# SOLICITATION AMENDMENT

SOLICITATION NO.	SOLICITATION DATE	AMENDMENT NO.	AMENDMENT DATE
266459	4/10/2014	01	4/23/2014
<b>ISSUED BY AND RETURN TO:</b> Washington River Protection Solutions, LLC P.O. Box 850 Richland, WA 99352 <a href="mailto:Michael_W_Voss@rl.gov">Michael_W_Voss@rl.gov</a>		<b>DUE DATE</b>	
		This amendment does not change the date by which offers are due unless a date and time is inserted below.	
		<b>DATE</b>	<b>TIME</b>

#### [Vendor Question for Solicitation 266459 MO-997 Replacement Trailer](#)

### Ci160QCT

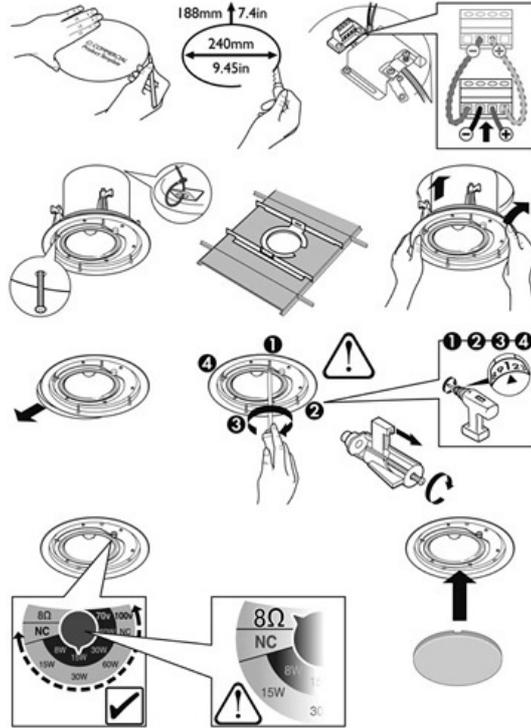
2. Furnish and install eight (8) ceiling mount speakers including 16/2 AWG speaker wire and hardware. Please provide spec for speakers.

Speakers should be similar to the attached cut sheet.

<b>SCREEN INNOVATIONS</b>	
Model No.	TRMFL110LG
Aspect Ratio	16:9
Material	Lunar HD

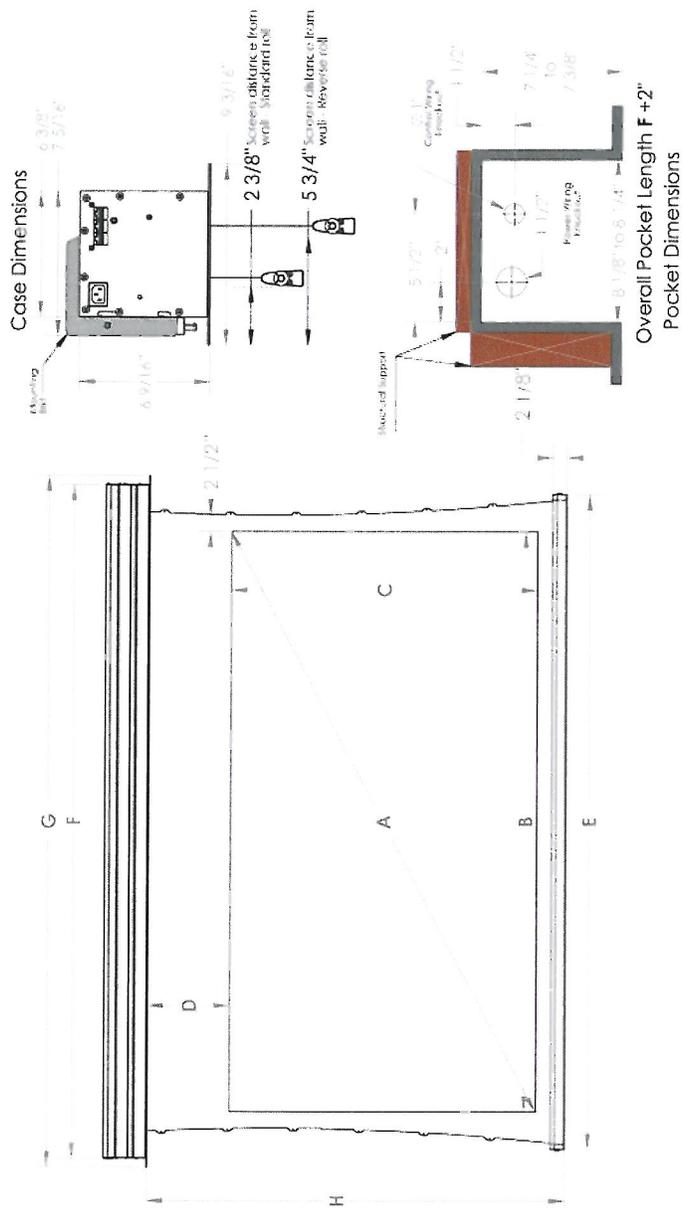
3. Furnish and turn over two (2) 8 FT wide (minimum), ceiling recessed, electric projector screens. Do you have a spec or preference on projector screen?

Screen should be similar to the attached cut sheet.
